RFQ# 2022-12
Request for Quotes
For the
Booster Pump Station Facility Upgrades

Addendum No. 1

Issued on October 27, 2022

C-02

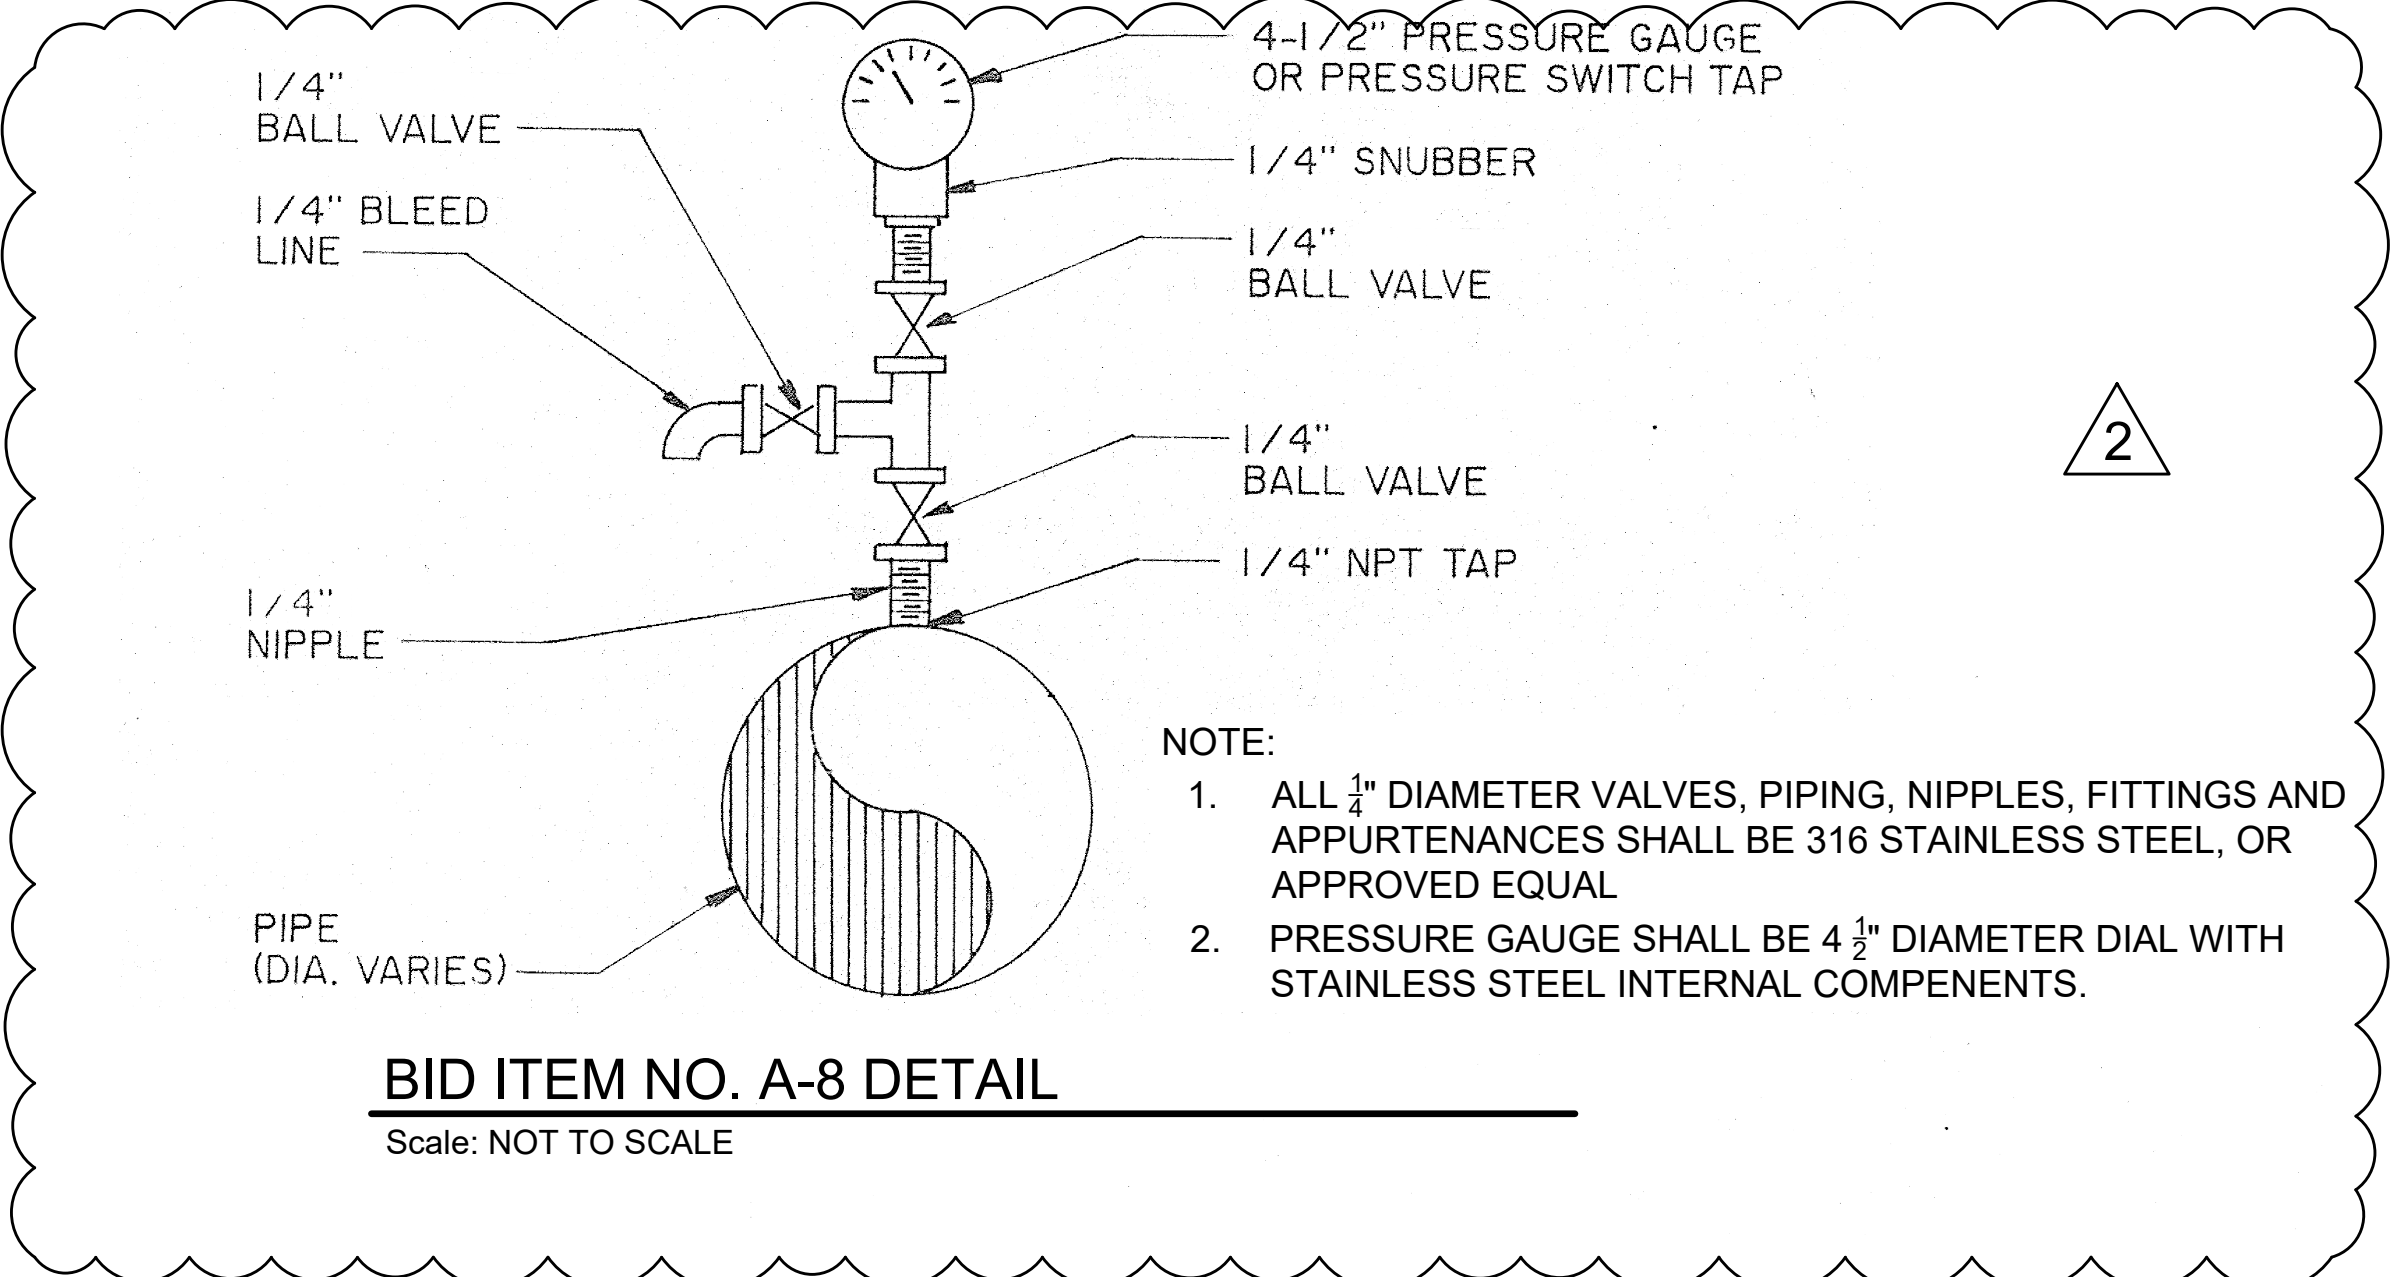
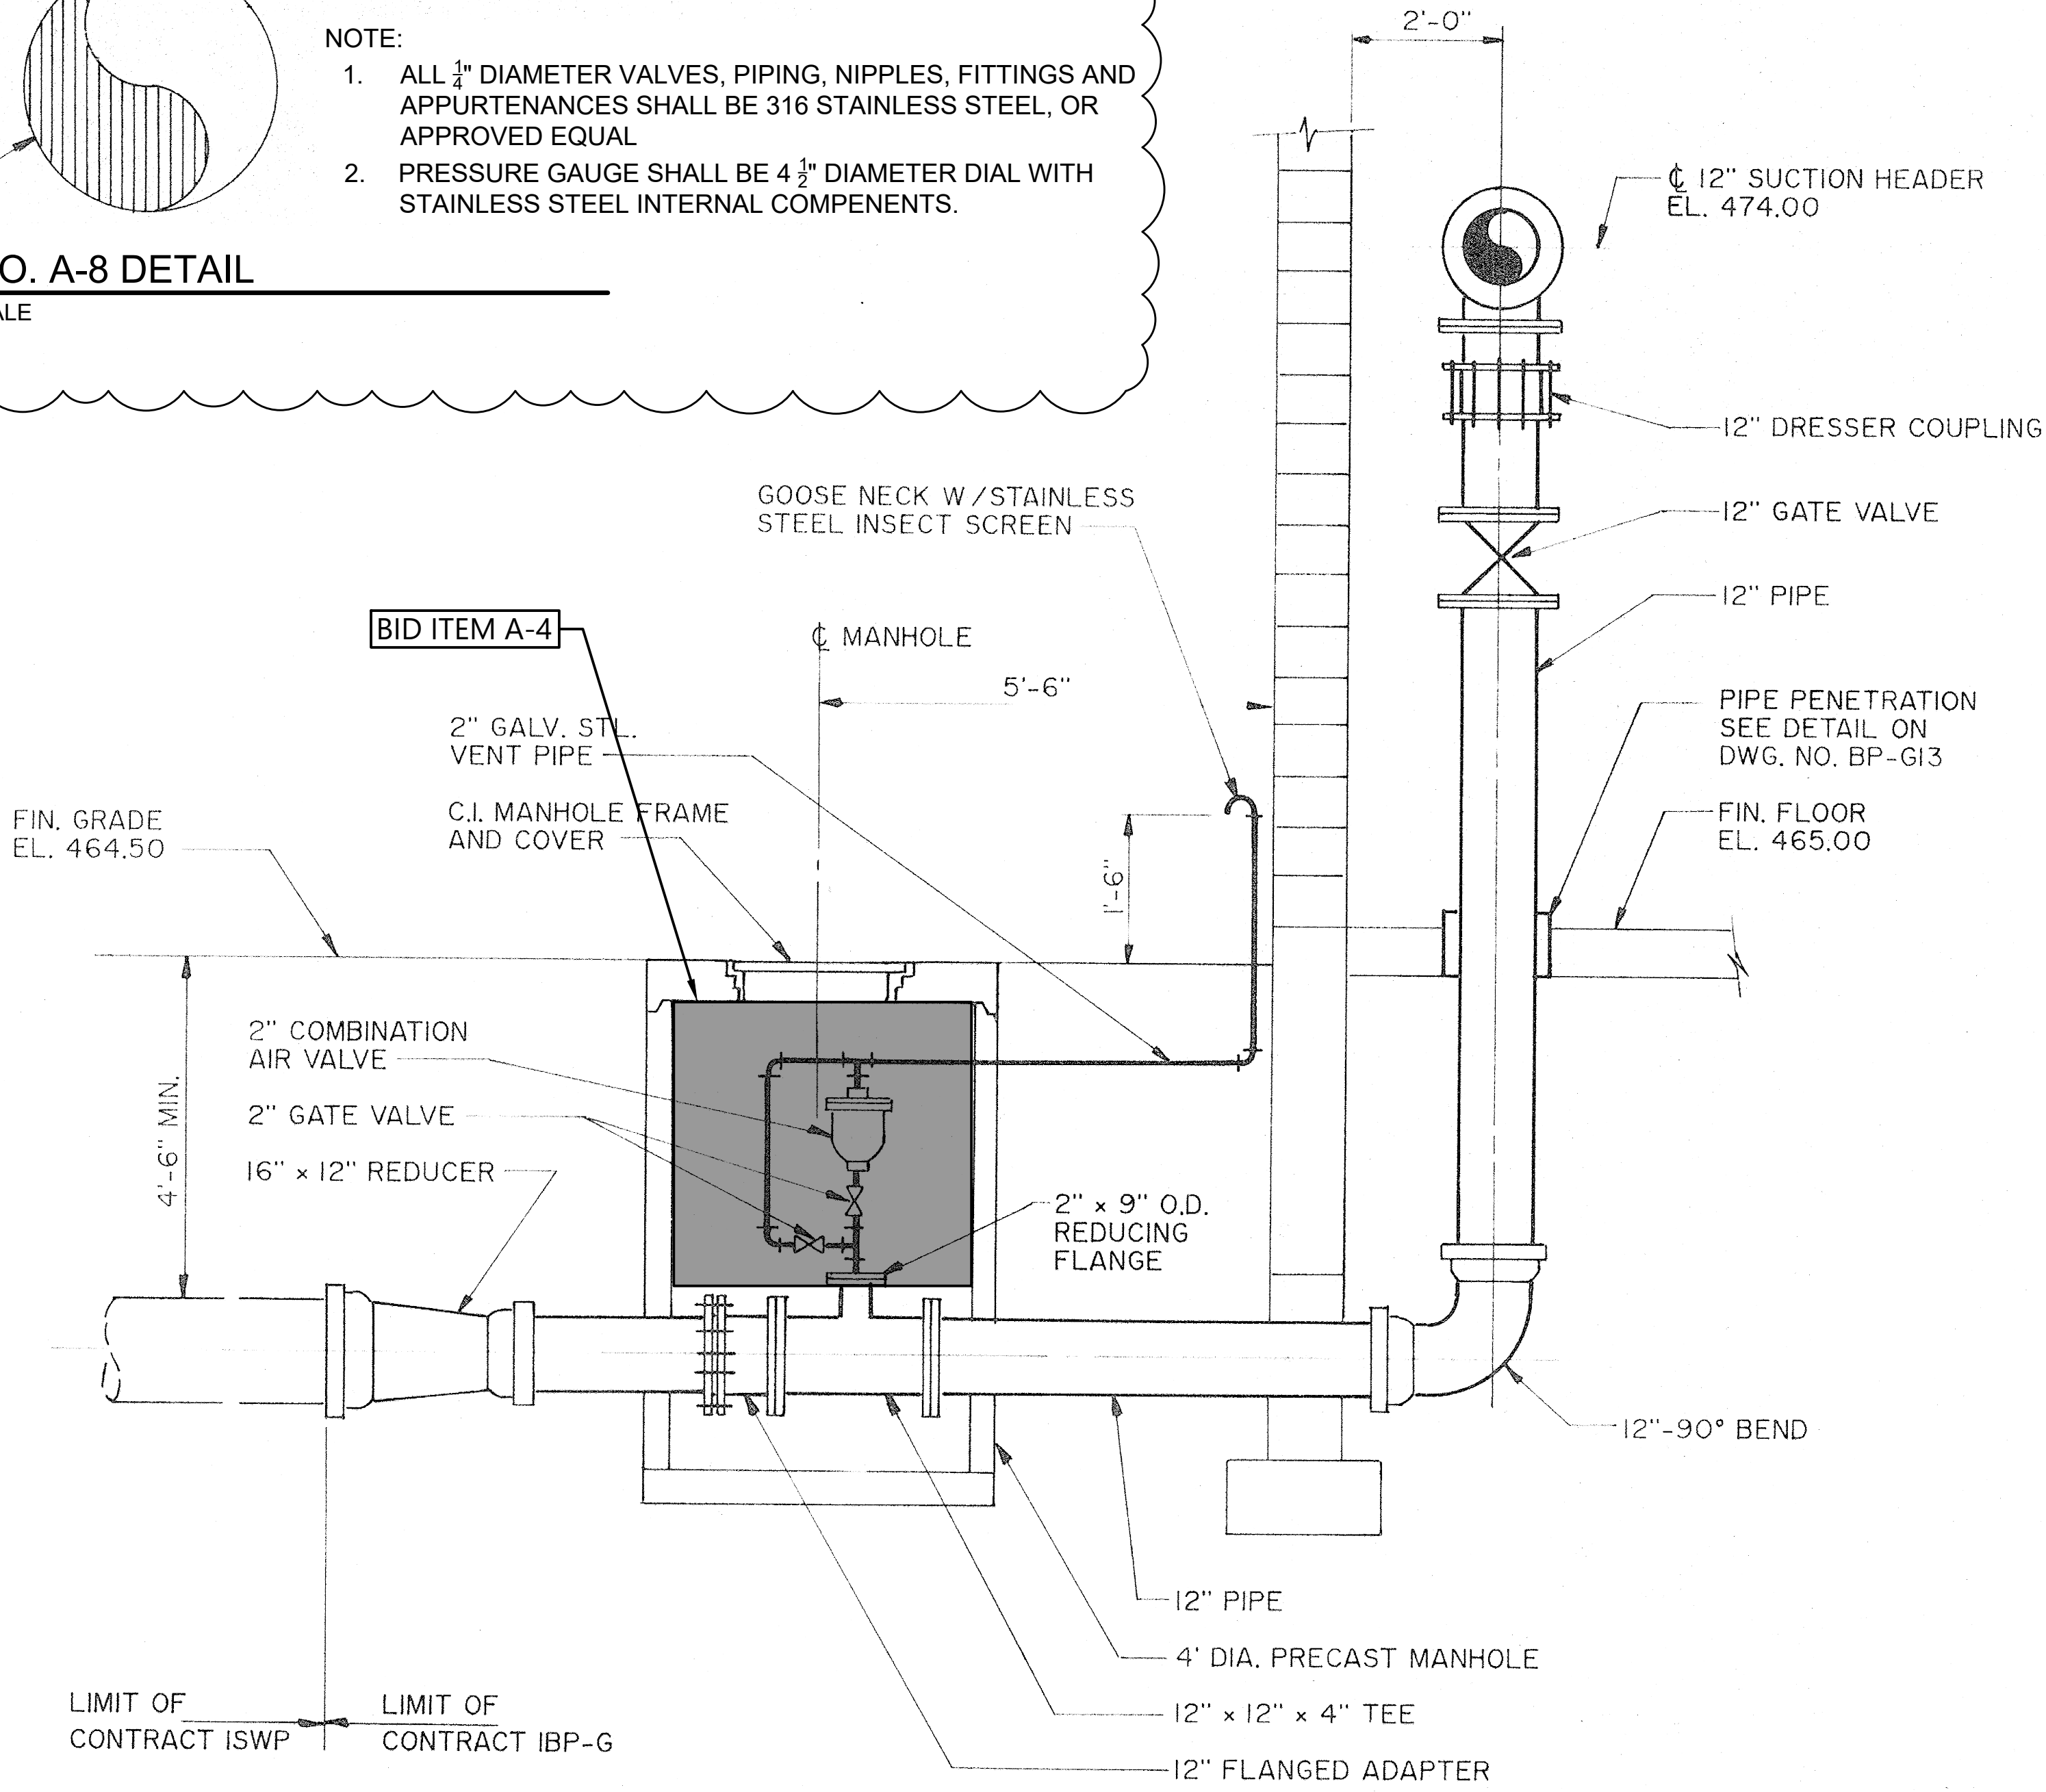
3. **Question:** In bid item A-4, spec calls for all new 316 SS pipe and fittings, drawing shows galvanized pipe. which is it?

Response: All new piping, valves, fittings, and appurtenance shall be 304 stainless steel. The existing vent line that shall be reused is galvanized. Contractor shall provide a dielectric fitting to prevent galvanic corrosion from dissimilar metals between the new and existing piping.

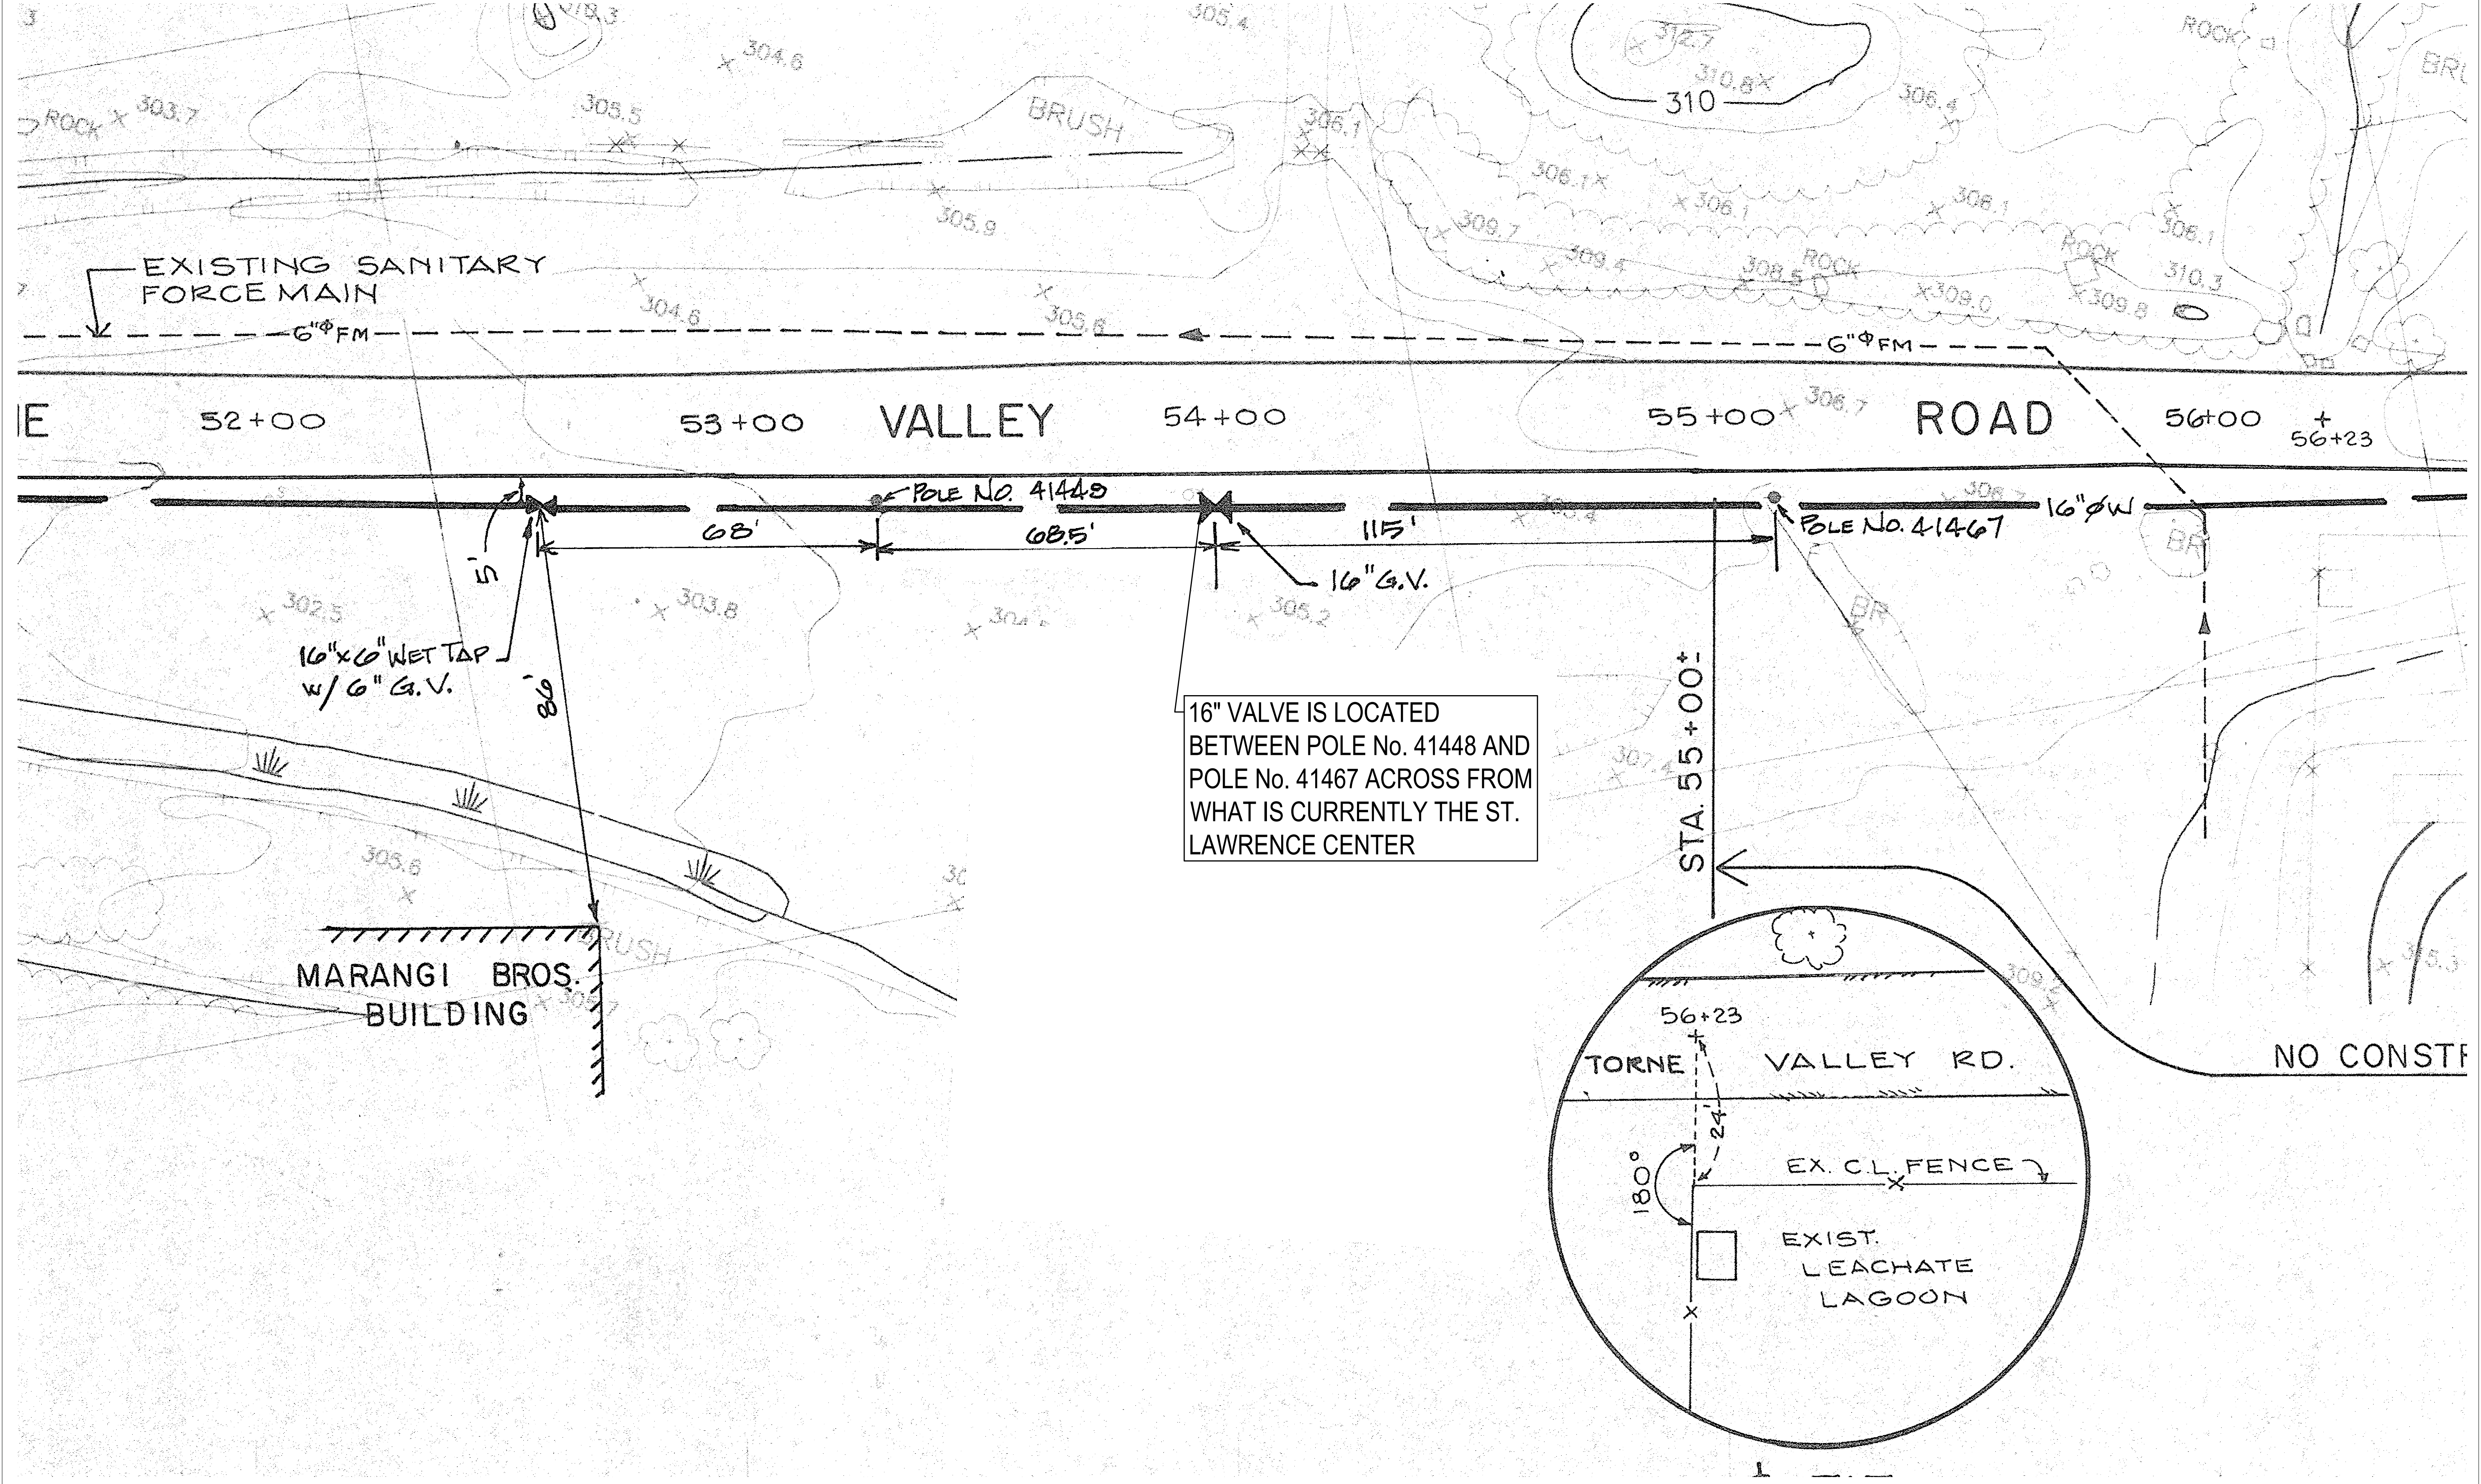
- The revised section 01026 includes added bid items No. A-7 and No. A-8
4. **ADD** drawing G-02 showing the location of the 16" gate valve located in Torne Valley Road between utility pole No. 41448 and No. 41467.

16" VALVE IS LOCATED BETWEEN POLE No. 41448 AND POLE No. 41467 ACROSS FROM WHAT IS CURRENTLY THE ST. LAWRENCE CENTER
